Lyons Haulage Site
Worthing Road, Littlehampton

RIGHT TURN LANE ACCESS DESIGN CHECK REPORT

ROAD SAFETY AUDIT - STAGE 1

ROAD SAFETY AUDIT DESIGNER'S RESPONSE

APPENDIX B: KEY PLANS

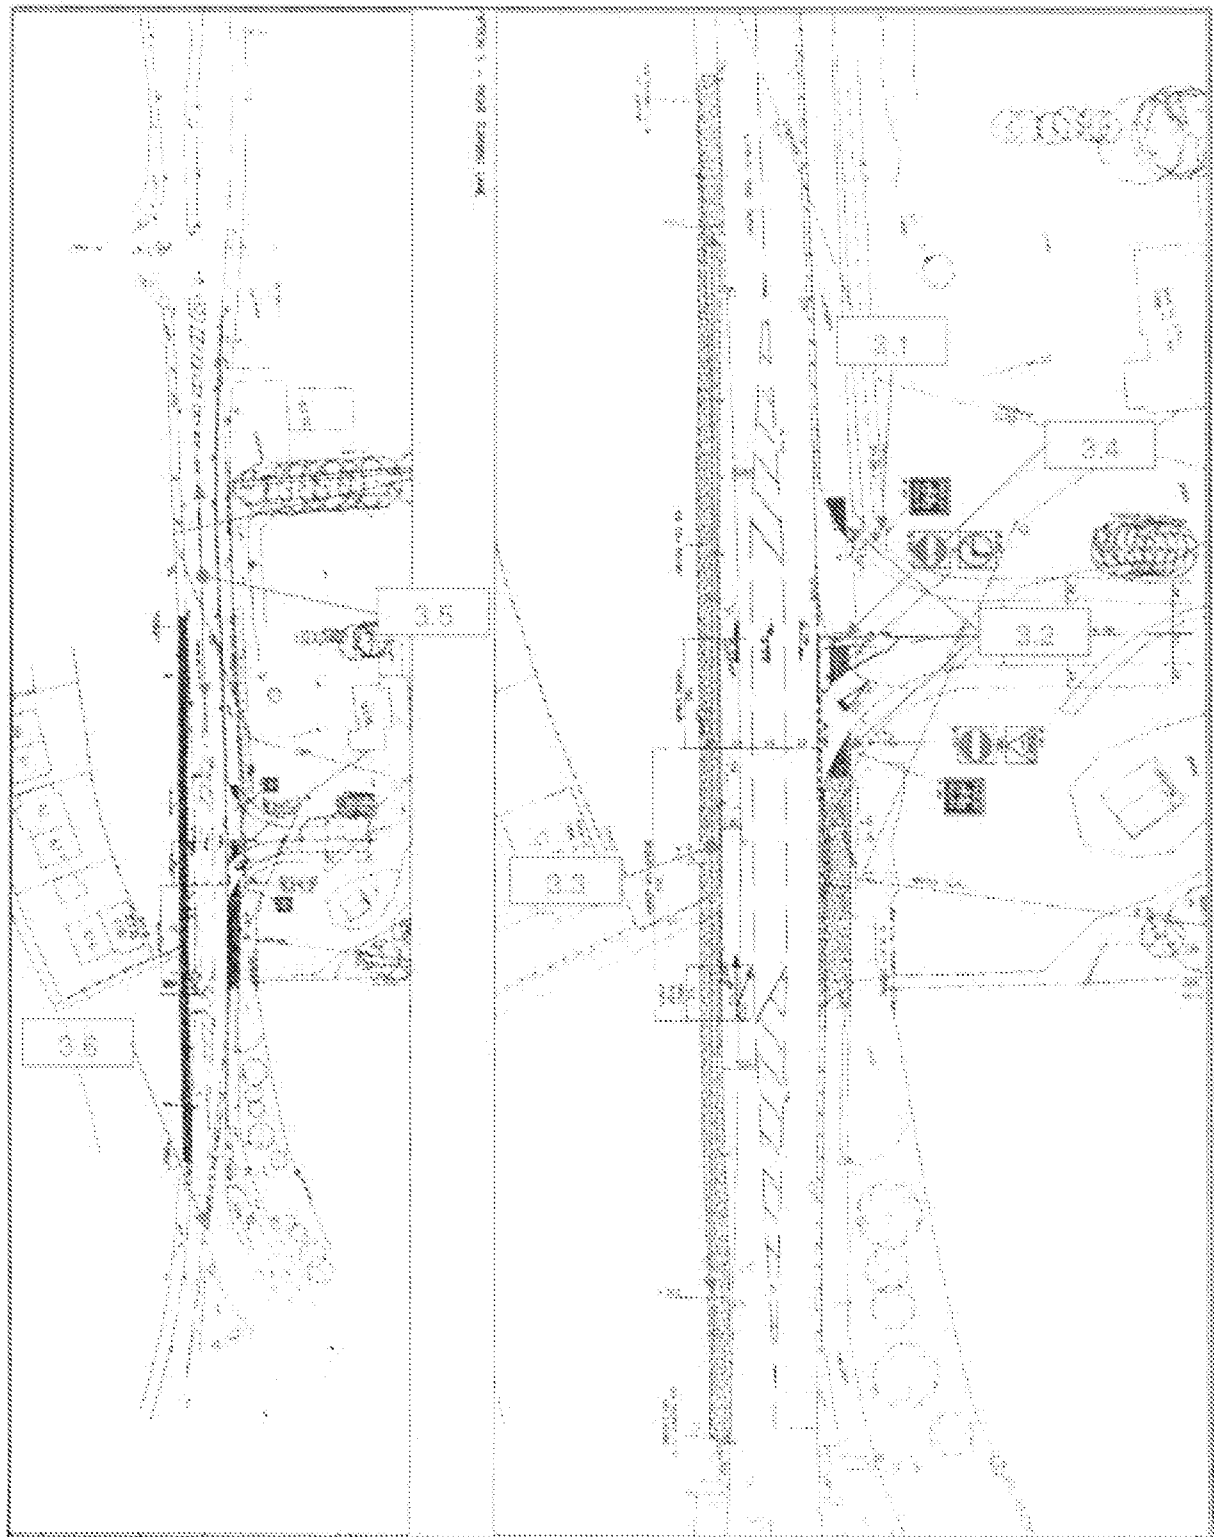
3.1 Problem

The 3 metre wide shared footway/cycleway across the development frontage and access, links up with the 2 metre wide footways either side of the access road that leads into the development. The 'end of route' sign on the western side of the access has been provided three metres beyond the start of the footway, effectively resulting in a localised narrow section of shared footway/cycleway. As a result there is an increased risk of conflict between cyclists (who may still not have dismounted at this stage) and pedestrians, and an increased risk of cyclists and pedestrians being forced into the live carriageway during busy periods.

The 'end of route' sign on the eastern side of the access may mask the 'no entry' sign behind it. This may result in drivers turning into the exit lane if the other sign is damaged or vandalised, increasing the risk of head-on collisions with vehicles/riders leaving the development.

3.2 Problem

Visually impaired pedestrians leaving the development along the 2 metre wide footway may not realise that they are entering an area shared with cyclists, increasing the risk of conflict.

3.3 Problem

There are a number of lighting columns, cabinets and road signs located adjacent to the existing footway. It is unclear if these are to be relocated or removed altogether. If they are to remain, they will reduce the effective width of

3.4 Problem

The hatching to the west of the splitter/traffic island is almost 400mm wide. Pedestrians may be inclined to wait in this area, increasing the risk of being struck by turning vehicles, in particular the rear sections of large right turning vehicles.

3.5 Problem

The provision of the right turn lane effectively removes the last overtaking opportunity along this section of Worthing Road. There is an increased risk that drivers may still try and overtake just prior to the hatching markings either side of the right turn lane, particularly in the eastbound direction, increasing the risk of collisions with vehicles waiting to turn right.

3.6 Problem

The widening of the carriageway to the south and introduction of the right turn lane has effectively introduced a relatively sharp 'kink' in the offside of the

westbound lane just prior to the start of the hatching east of the right turn lane. As a result there is an increased risk of vehicles that are leaving the roundabout, overrunning the opposing carriageway, increasing the risk of head-on collisions.

Relocate the 'end of route' sign on the western side of the access closer to the start of the footway.

Relocate either the 'end of route' sign or the 'no-entry' sign (or both) to prevent any of the signs being masked.

Make visually impaired pedestrians aware that they are entering a shared area, by providing corduroy paving (in accordance with *Guidance on the use of tactile paving surfaces, Department for Transport, 2005*) to coincide with the 'end of route' signs. (Also refer to the recommendation for Problem 3.1)

Reduce the risk of injury to pedestrians using the new footway along the southern side of Worthing Road by removing or relocating all road side furniture off the footway (i.e. south of the footway). Ensure all this furniture has adequate vertical and horizontal clearance for pedestrians.

Reduce the risk of pedestrians waiting in the hatch area being struck by vehicles by reducing the width of the hatching or increasing the width of the island.

Provide protection for right turning vehicles by providing a traffic island with appropriate keep left signage and bollards within the hatching markings to the west of the right turn lane.

Alternatively, link this hatched markings area with the hatched markings further to the west.

Keep opposing vehicles apart by joining up the hatched markings to the east of the right turn lane and the hatched markings on the roundabout splitter island.

3.1	Yes	Yes	'End of route' sign has been relocated closer to the start of the footway as demonstrated in drawing no. 022.1832.202.P7	Agreed with relocation of 'End of route' sign on western side of access. Widen the shared footway/cycleway to 3m right up to the corduroy paving. 'End of route' sign on the eastern side of the access is positioned behind the corduroy paving, effectively extending the shared footway/cycleway through a localised narrowed section. This may increase the risk of conflict with pedestrians, particularly with the abundant vegetation adjacent to the shared footway/cycleway restricting forward visibility. Move sign post (combination) in adjacent to or in advance of (i.e. south of) the corduroy paving. Remove vegetation in the visibility splays for approaching cyclists and drivers. Widen the shared footway/cycleway to 3m right up to the corduroy paving.

3.2	Yes	Yes	Corduroy paving has been added at the start of the footway as per 'Guidance on the use of tactile paving surfaces, DfT 2005'. This is demonstrated in drawing no. 022.1832.202.P7	Agreed

3.3	Yes	Yes	All services and road side furniture will be relocated to the back of the footway and to be addressed at detailed design stage.	Agreed
3.4	Yes	Yes	The splitter island has been repositioned and hatching width reduced to prevent pedestrian waiting in the hatched area as demonstrated in drawing no. 022.1832.202.P7	Agreed

3.5	No	No	The proposed right turning lane will have an identical right turning layout as per other right turning facilities on Worthing Road. The only single lane dualing is on Toddington Lane to stop rat running and this is not applicable to this site.	The risk of overtaking along this section still remains. Provide protection for right turning vehicles by providing a small traffic island with appropriate keep left signage and bollards within the hatching markings to the west of the right turn lane (west of the junction). Alternatively, link this hatched area with the existing hatched area just to the west (for example with a 800mm wide hatched strip).

3.6	No	No	Proposed road marking will tie into the existing signalised pedestrian crossing as demonstrated in drawing no. 022.1832.202.P7	Agreed. The general alignment of exit from the roundabout is much improved and the 'kink' in the offside of the westbound lane effectively removed.
